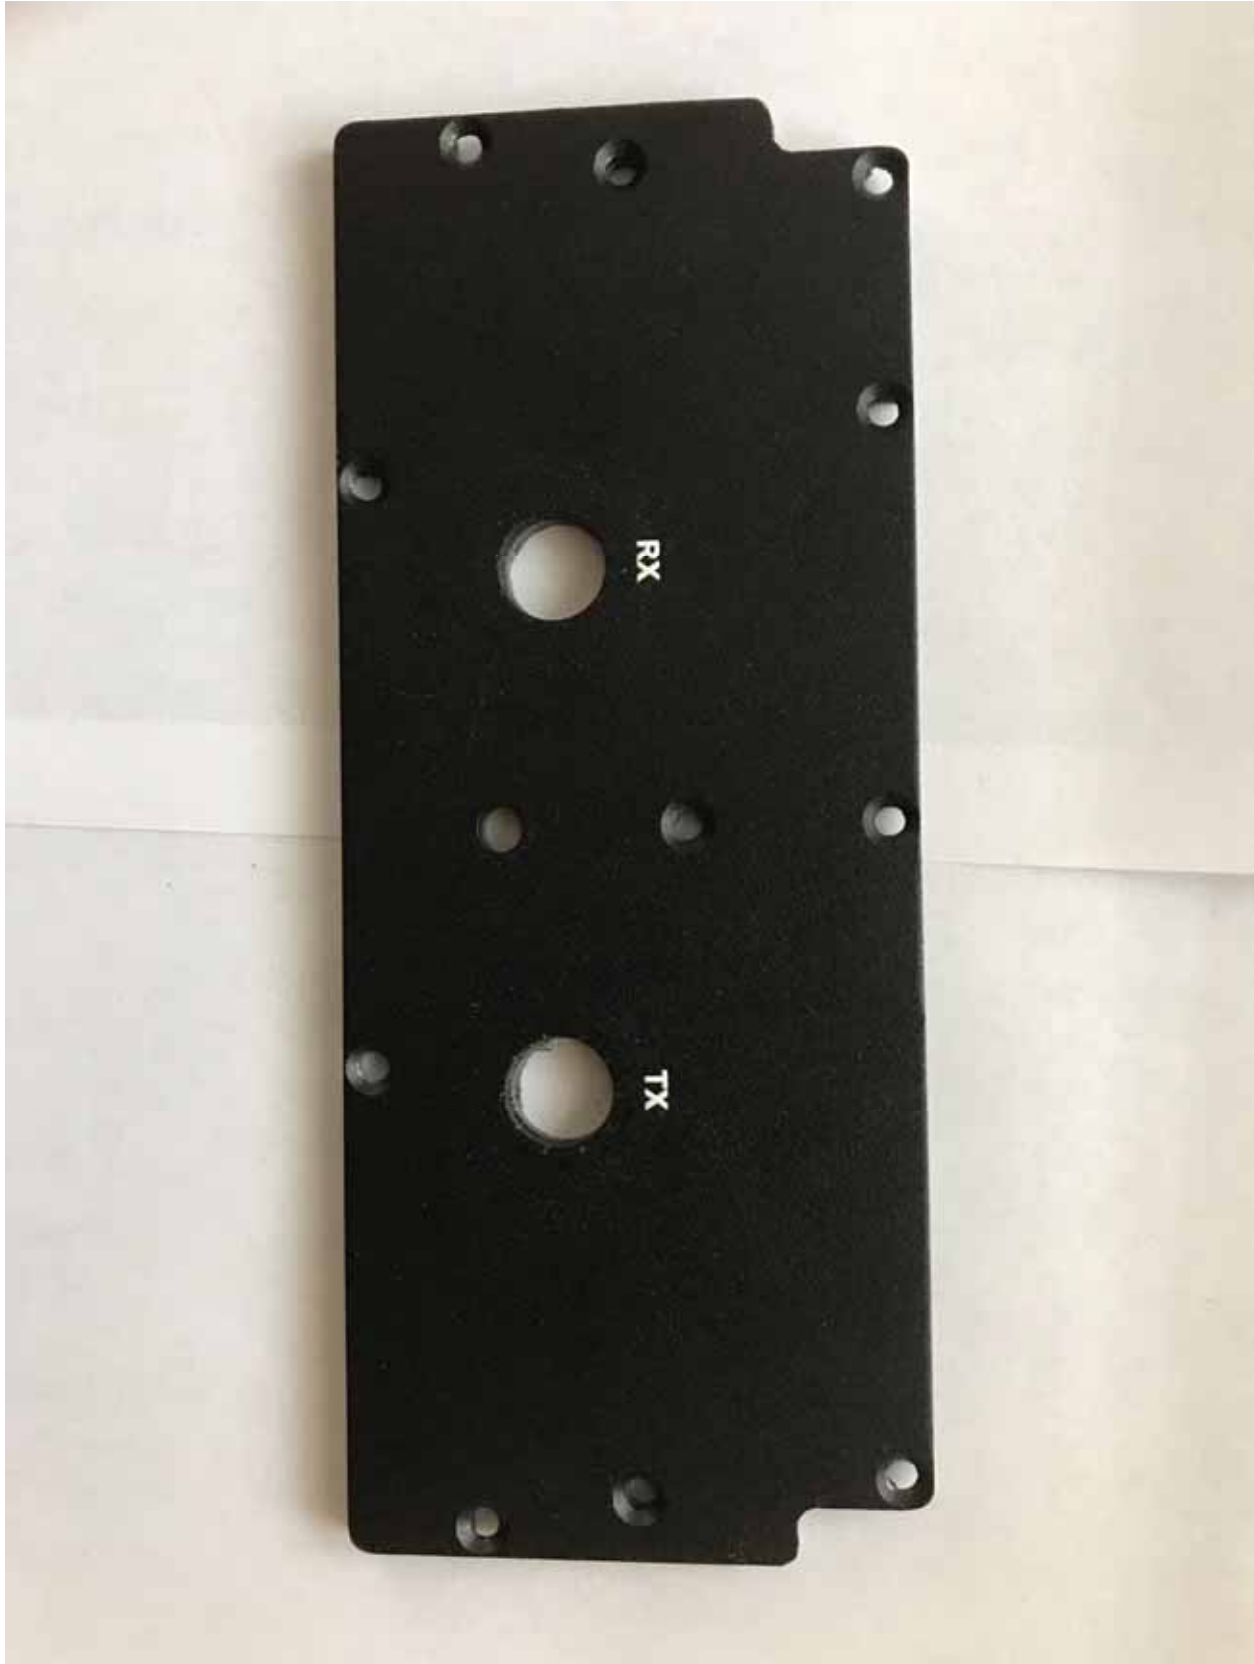
Foil was added on the EMI gasket

The cover is 4mm larger and a screw was added in the upper left corner.
The cover now displays DVR-LX.

Finger stock was added on both long partition edges.

Finger stock was added on both long partition edges.

The cover is 4mm larger and the upper right screw was added

New TNC connectors.

New TNC connectors.
